RE: Alamo Warehouse 2350 Alamo Ave SE Conceptual Grading and Drainage Plans

> Engineer's Stamp Date: 10/18/23 Hydrology File: M16D011E

Based upon the information provided in your submittal received 10/30/2023, the Conceptual Grading & Drainage Plans are preliminary approved for action by the Development Facilitation Team (DFT) on Site Plan for Building Permit.

> SHEET # GR-1

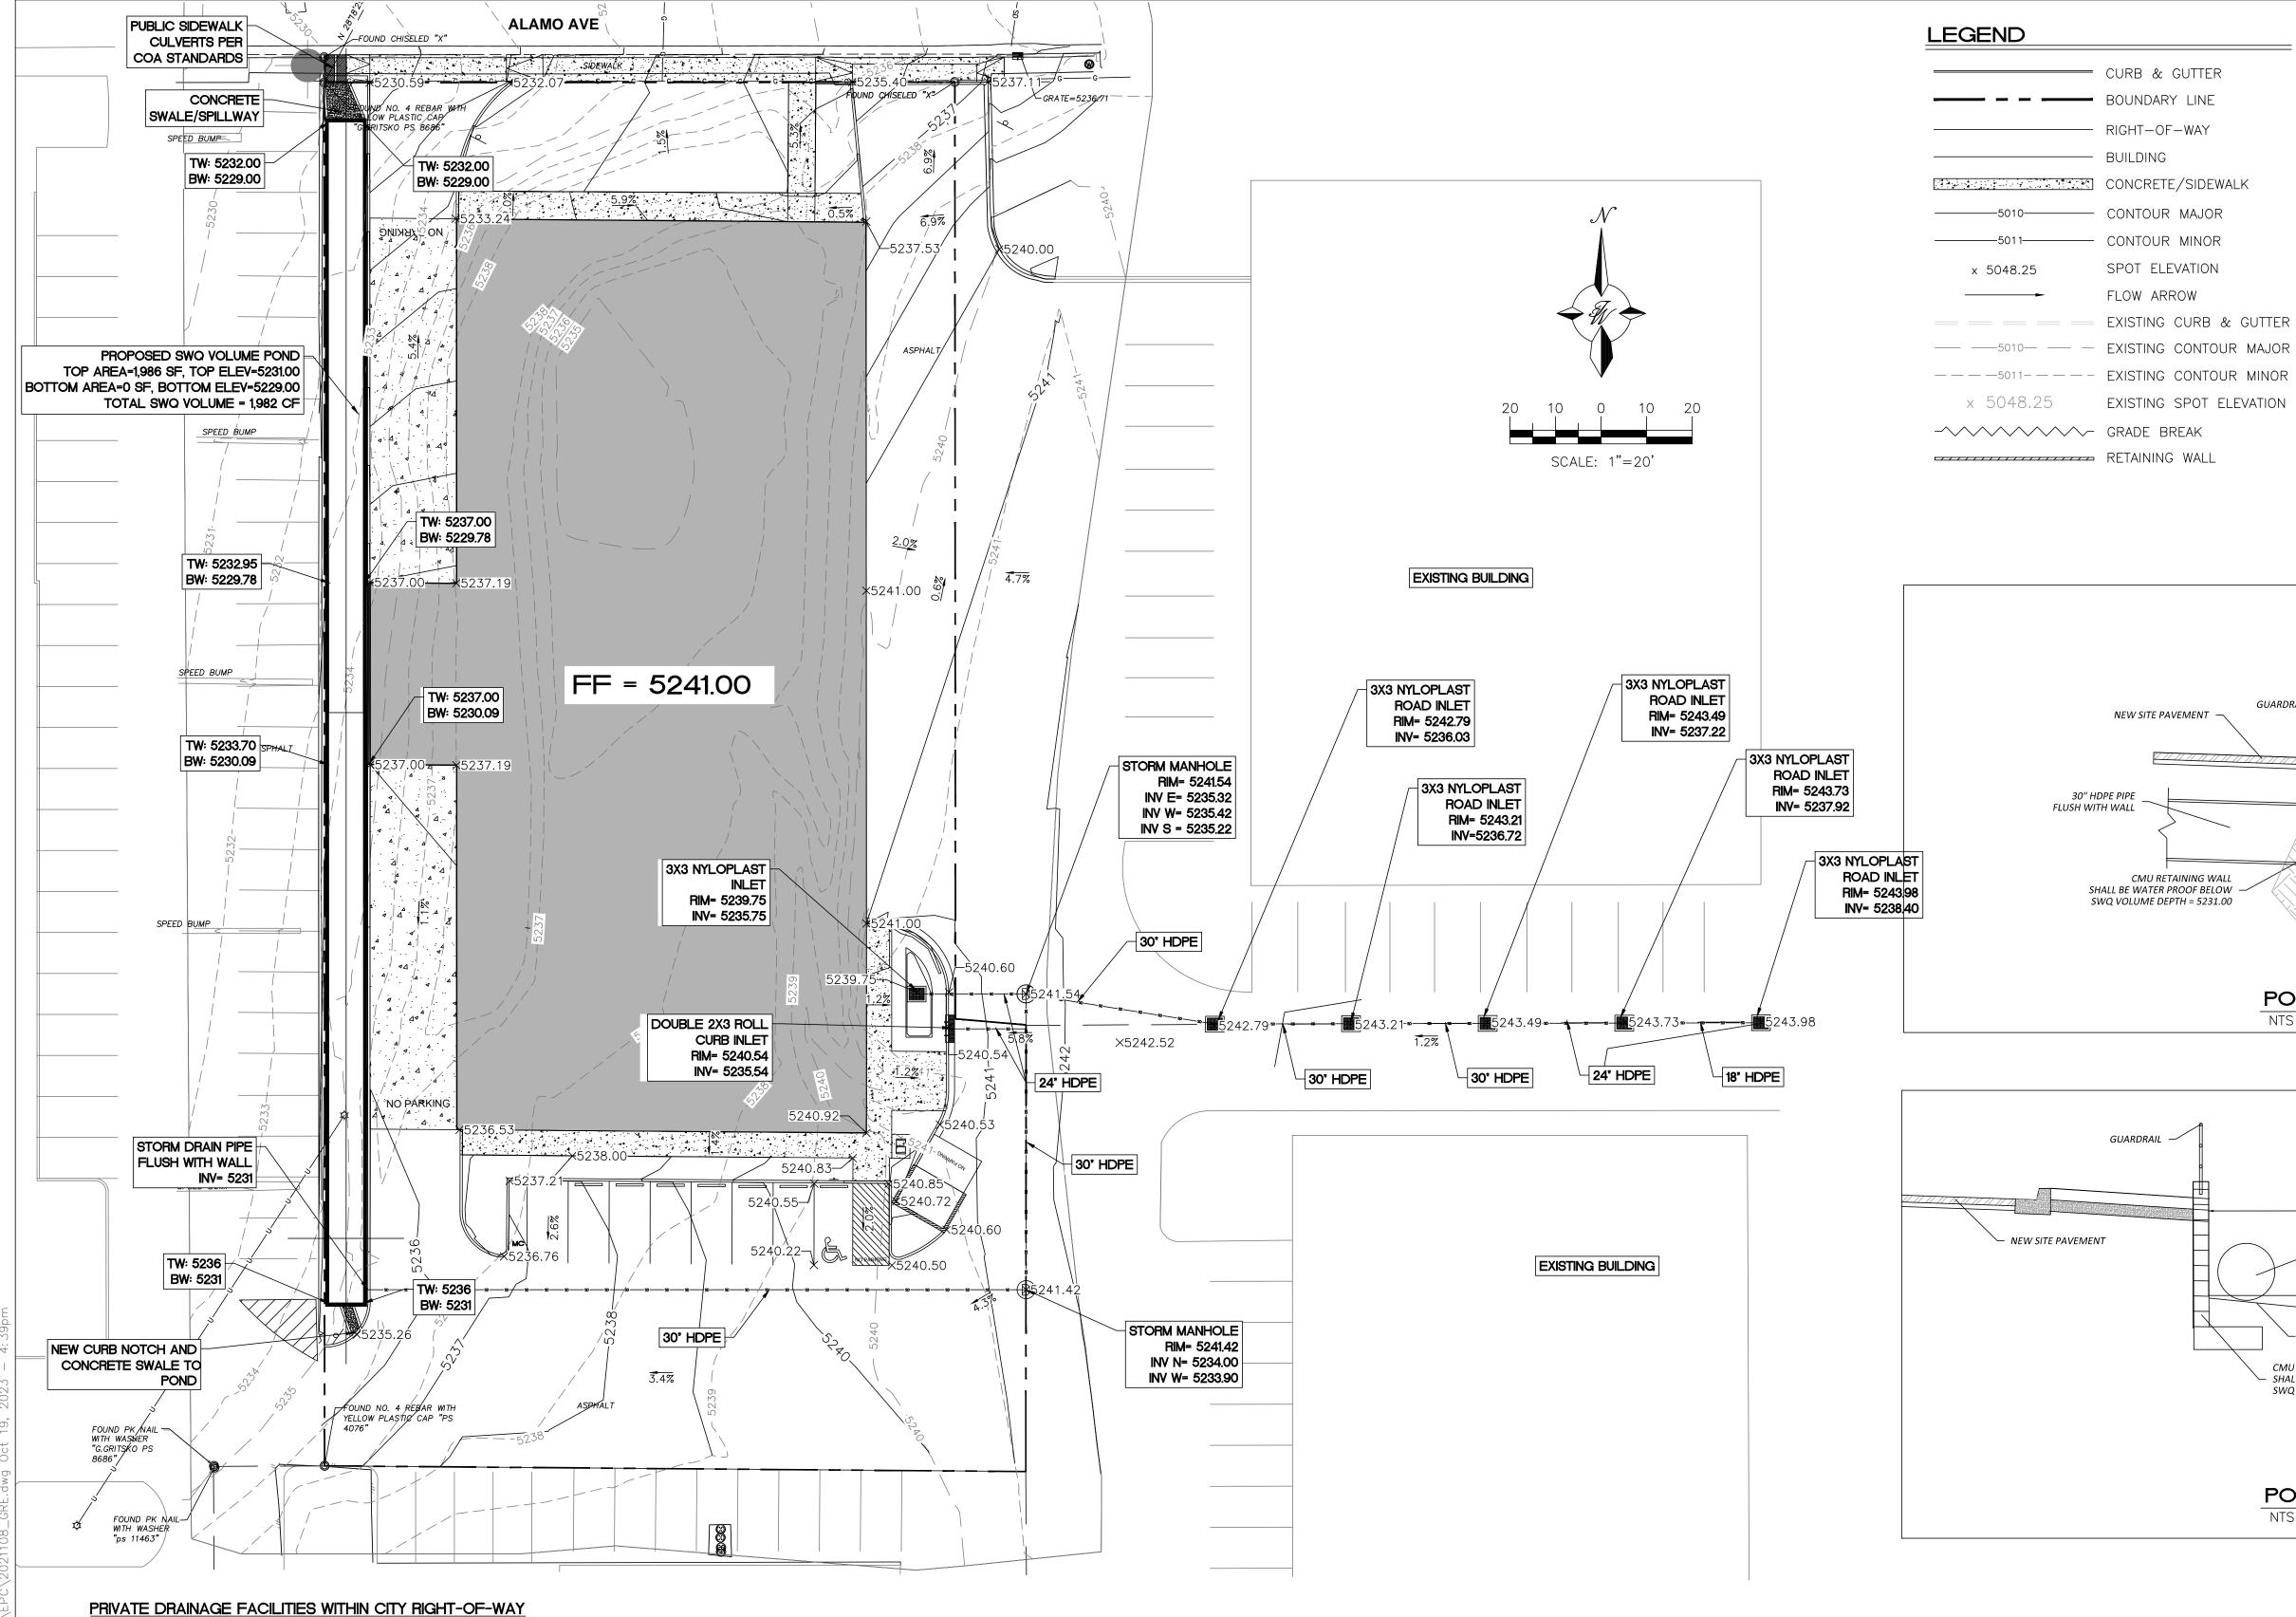
1. Please submit a more detailed Grading & Drainage Plan to Hydrology for review and approval. This digital (.pdf) is emailed to PLNDRS@cabq.gov along with the Drainage Transportation Information Sheet.
